Final Drainage Report

**Tract A, Wilsons Widefield  
Addition No. 6  
El Paso County, Colorado**

PCD File Number: PPR-22-009

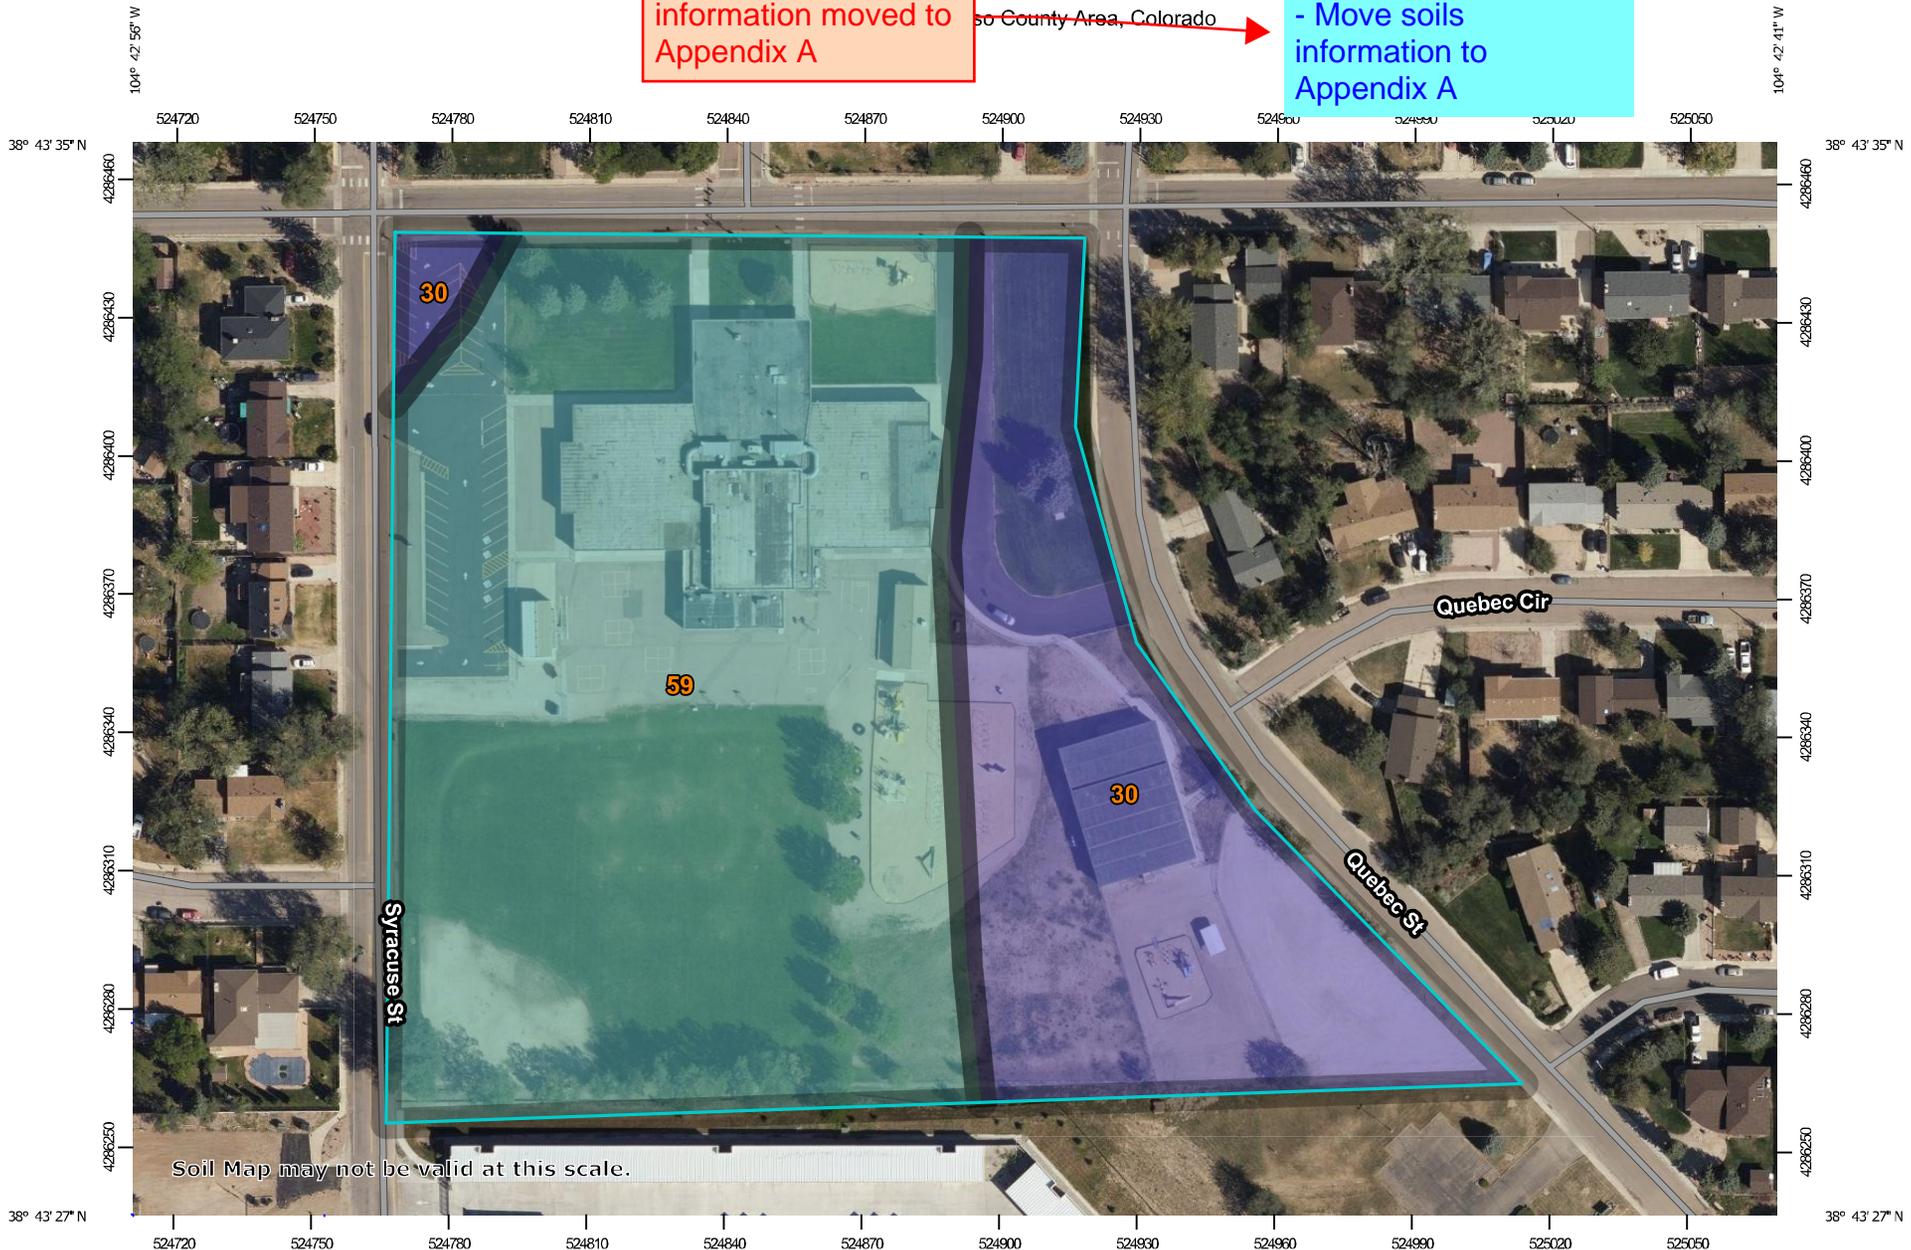
Unresolved comment: - Move soils information to Appendix A

Noted, Soils information moved to Appendix A

## Cross Section for 8" Trench Drain

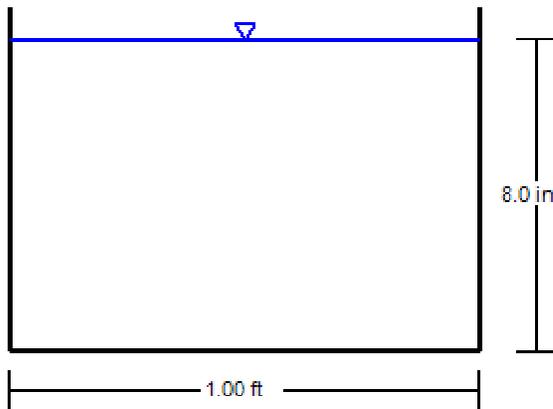
Include velocity

Data Worksheet added

## Cross Section for Pr. 12" RCP Culvert (East Entrance)

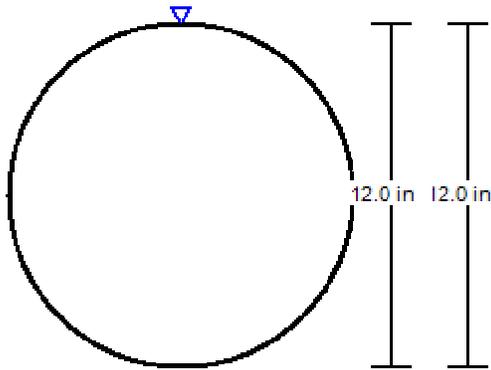
Include velocity

How does the culvert has a smaller required flow than the swale directing flows to it? (Swale design on previous sheet has 3.11 cfs).

Include calculation for outlet protection for culvert. (May not be needed with such small flow, but calculation needed to show that)

Calculations show minor outlet protection. 3x2 type L riprap pad added to outfall of culvert
